PROPOSED EXTENSION TO HOUSE SHOWER ROOM, STUDY AND UTILITY ROOM, PROVIDE SUN LOUNGE, AND PORCH TO FRONT	
PROJECT	
PROPOSED SINGLE STOREY EXTENSION TO 51 HEOL Y NANT BAGLAIN PORT TALBOT SALIZZER FOR CHRISTIANIA LLOYD	
DRAWING	
to be read in conjunction with IL20-200-01C	
DRG. No.	IL20-200-02B
REVISION	Rev B - Amended extension and roof details
SCALE	DATE
- 1:50	26/03/20

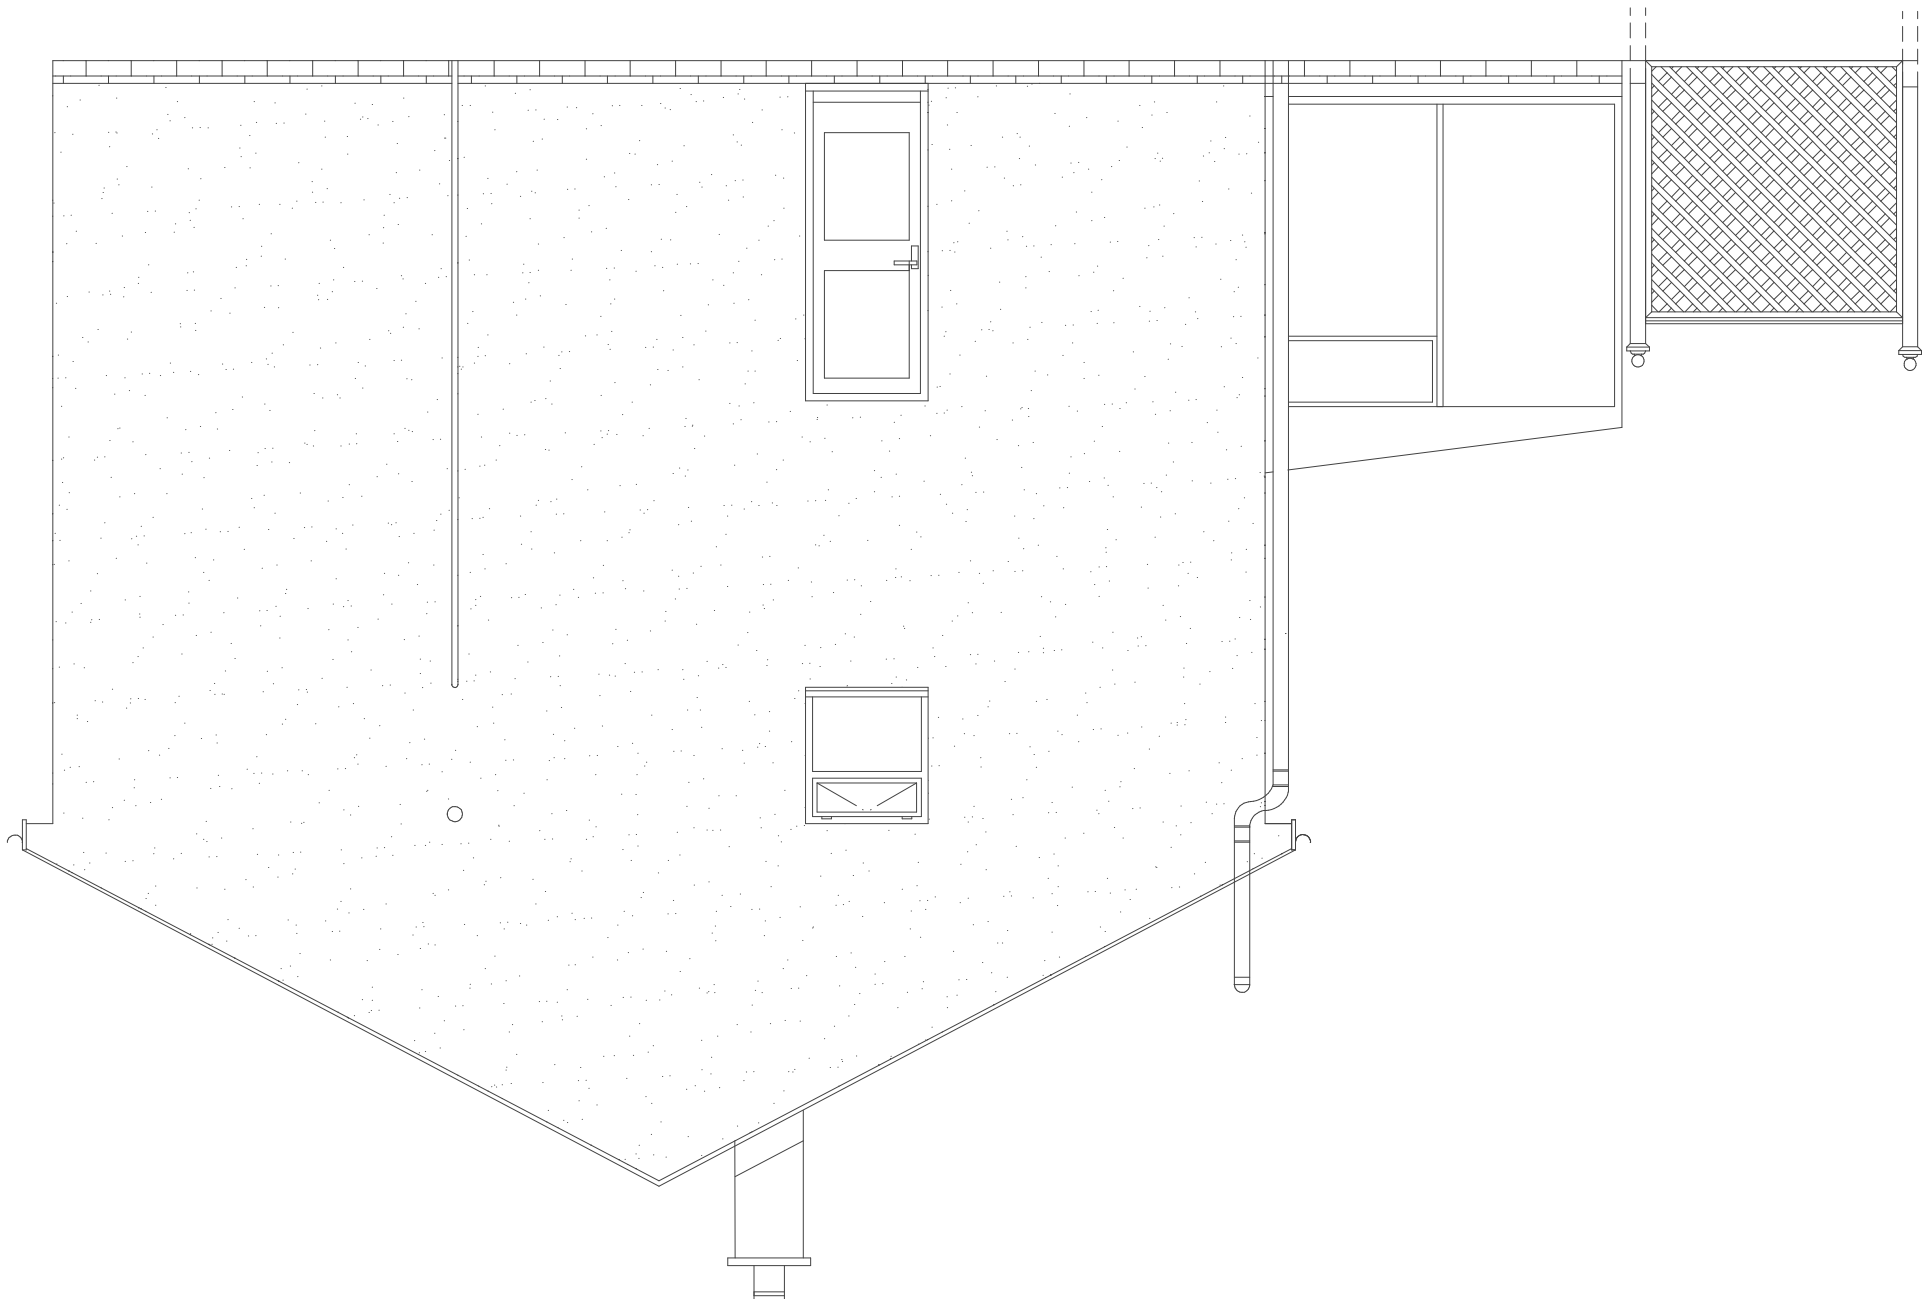
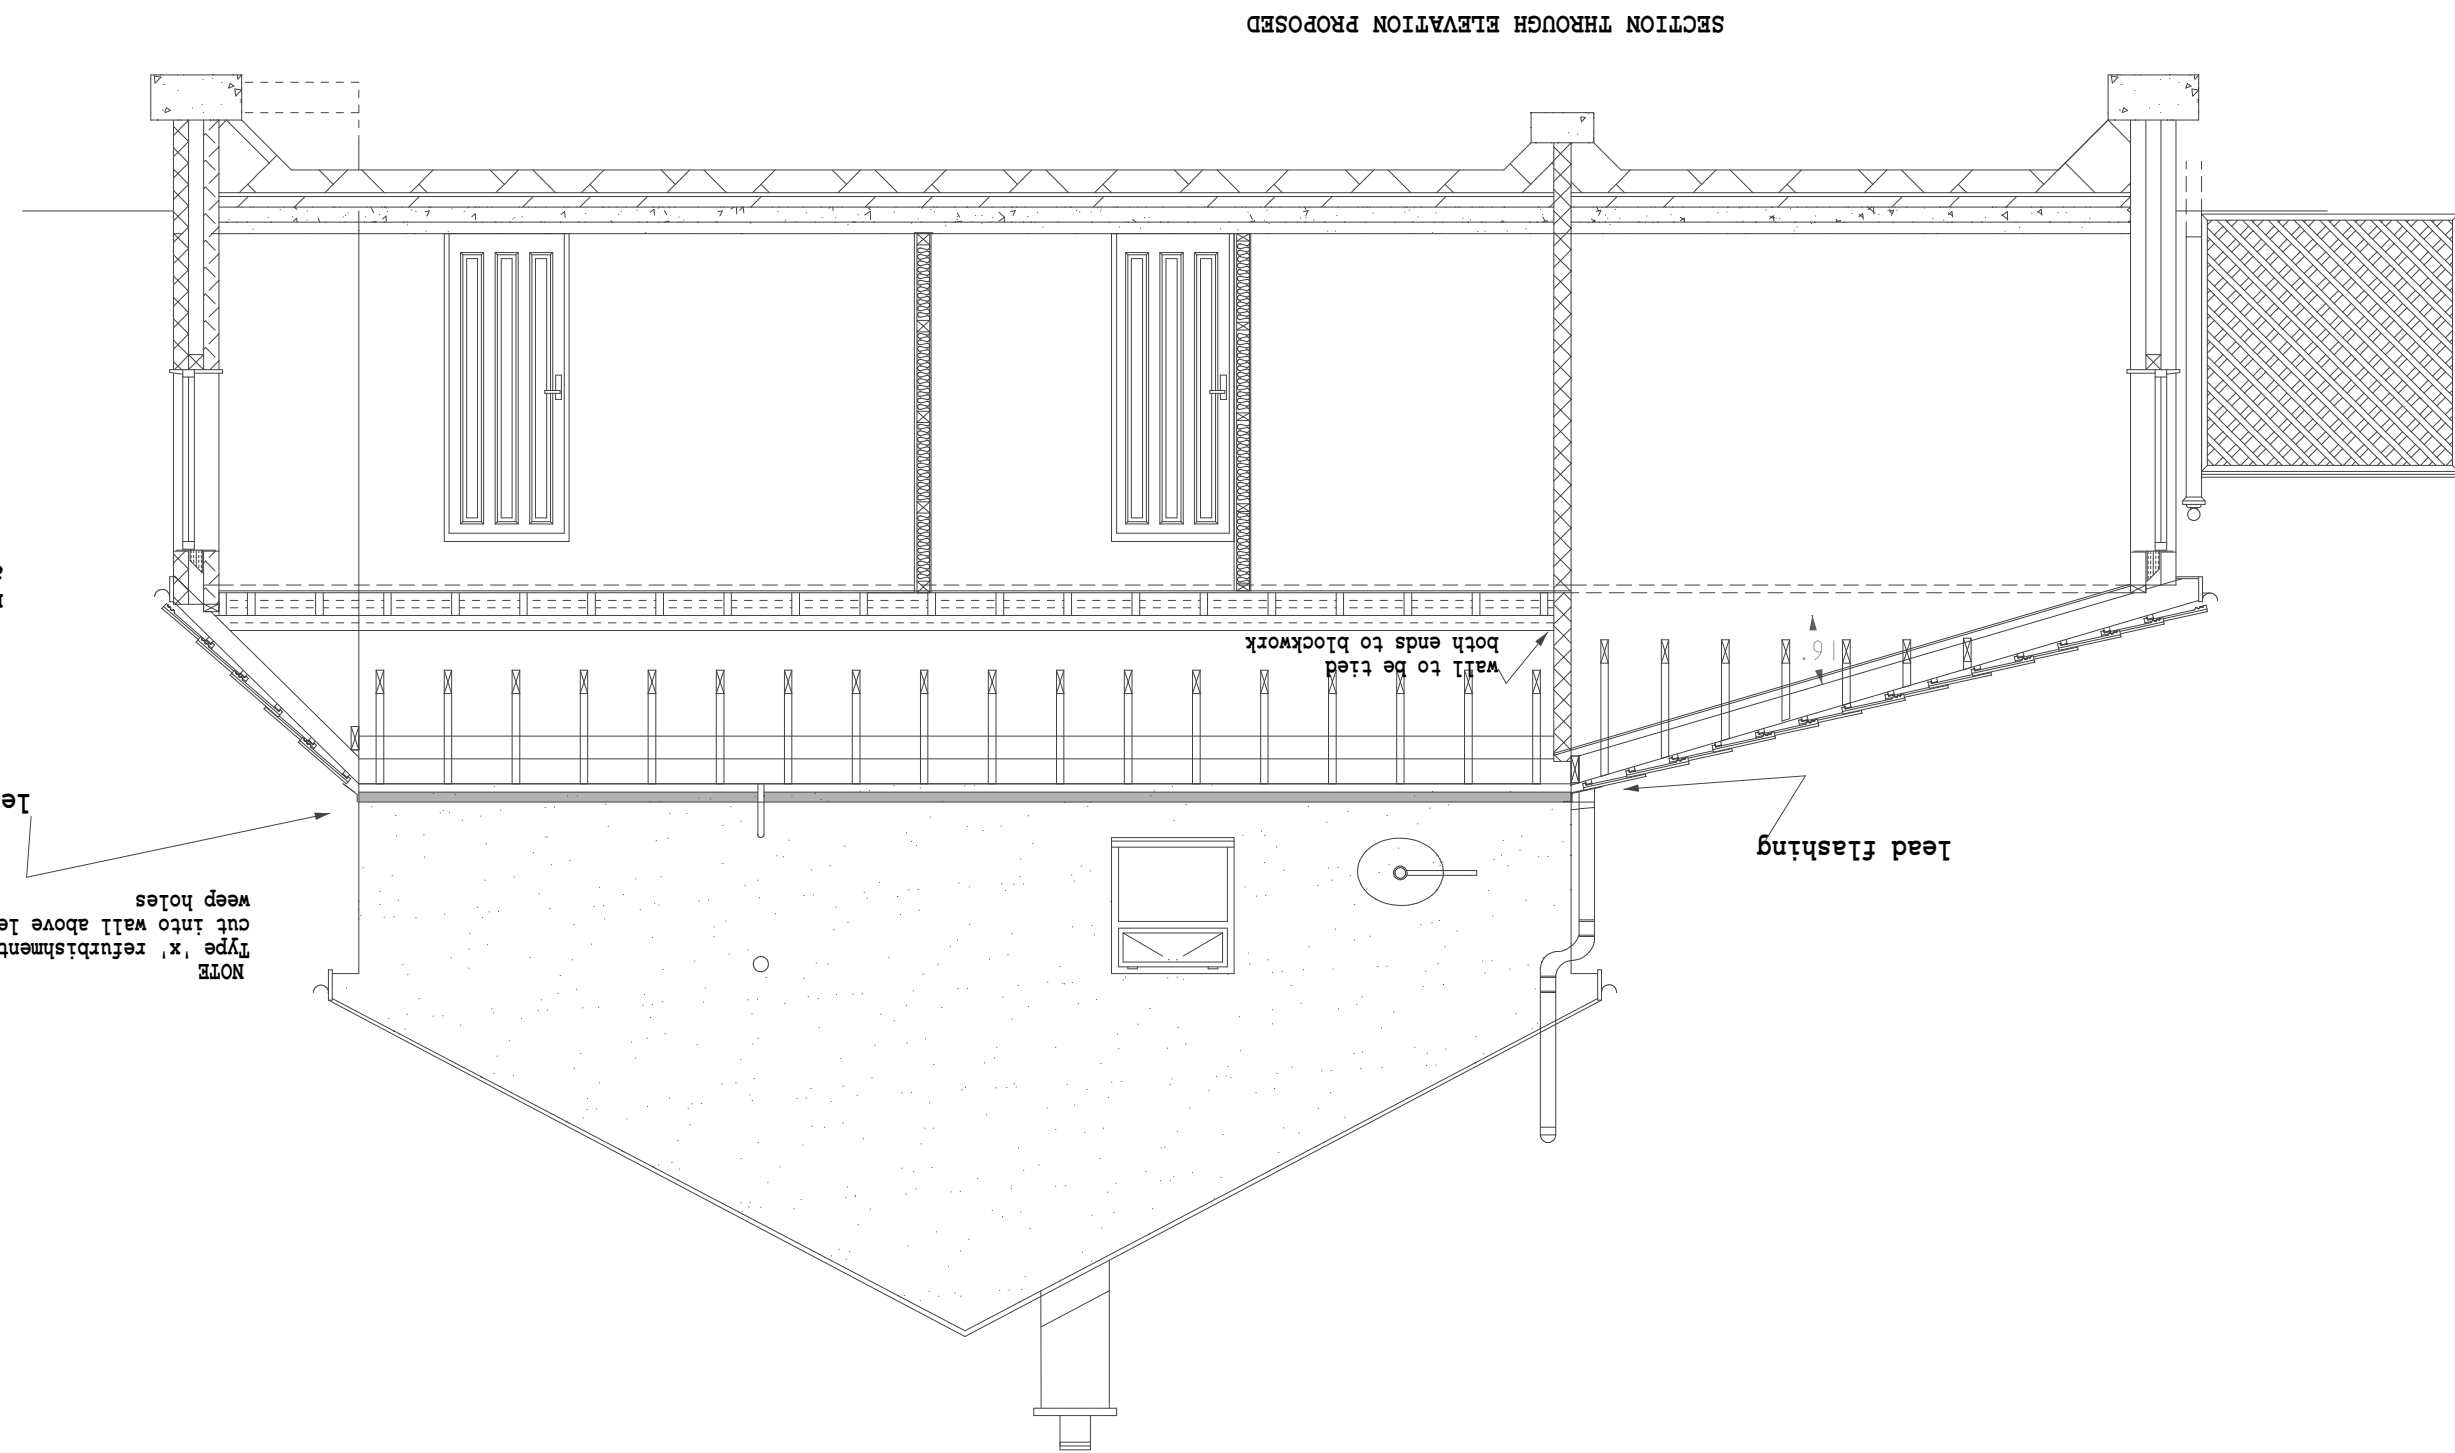
Take out window and sill to
make bedroom build up sill
to match main bathroom sill
Chick to enable pitch roof
at 16" to enable raised roof
panes to be fitted in line
Check roof pitch of 16"
achieved to below bedroom
area, existing ventilation
to roof.
Design to be fully in
accordance with structural
engineers calculations for all
structural support including
beams, hip rafters, foundations
and piers
